SUNDRY NOTICES AND REPORTS ON WELLS				5. Lease Serial No.	
Do not use this form for proposals to drill or to re-enter an abandoned well. Use Form 3160-3 (APD) for such proposals				NMNM-66425 6. If Indian, Allottee or Tribe Name	
SUBMIT IN TRIPLICATE				7. Unit or CA Agreement Name and No.	
1a. Type of Well Oil Well Gas Well Other				- 7. Olik oli O/C/Igrodilichi Halilo ulia Ko.

- On Well Constitution of the Constitution of				8 Well Name and No.	
2. Name of Operator				Laguna Salado 22 Federal 6H	
DEVON ENERGY PRODUCTION COMPANY, LP				9. API Well No.

12. CHECK APPROPRIATE BOX(s) TO INDICATE NATURE OF NOTICE, REPORT, OR OTHER DATA					
TYPE OS SUBMISSION TYPE OF ACTION					
☐ Subsequent Report ☐ Alter Casing ☐ Fracture Treat ☐ Reclama ☐ Casing Repair ☐ New Construction ☐ Recomplements			ete rily Abandon	Water Shut-Off Well Integrity Other Rig Layout 8 BOP Change	
deepen directionally or recomplete horizontally, give subsurface location and measured and true vertical depths of all pertinent markers and zones. Attach the Bond under which the work will be performed or provide the Bond No. on file with BLM/BIA. Required subsequent reports shall be filed within 30 days following com

11" x 5,000 psi BOP Stack

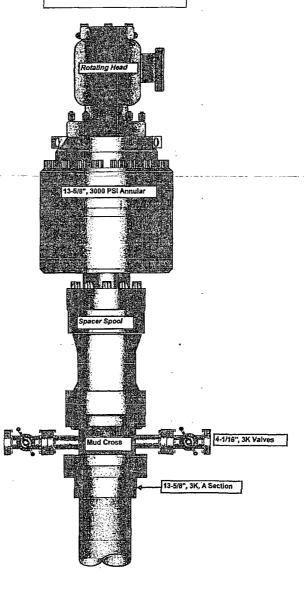
The BOP system used to drill the intermediate hole will consist of a 13-5/8" 3M Annular preventer. The BOP system will be tested as per BLM Onshore Oil and Gas Order No. 2 as a 2M system prior to drilling out the surface casing shoe.					
The BOP system used to drill the production hole will consist of a 36 5 5 M Double Ram and Annular preventer. The BOP system will be tested as per BLM Onshore Oil and Gas Order No. 2 as a 5 M system prior to drilling out the intermediate casing shoe.					
The pipe rams will be operated and checked each 24 hour period and each time the drill pipe is out of the hole. These tests will be logged in the daily driller's log. A 2" kill line and 3" choke line will be incorporated into the drilling spool below the ram BOP. In addition to the rams and annular preventer, additional BOP accessories include a kelly cock, floor safety valve, choke lines, and choke manifold rated at 3,000 psi WP.
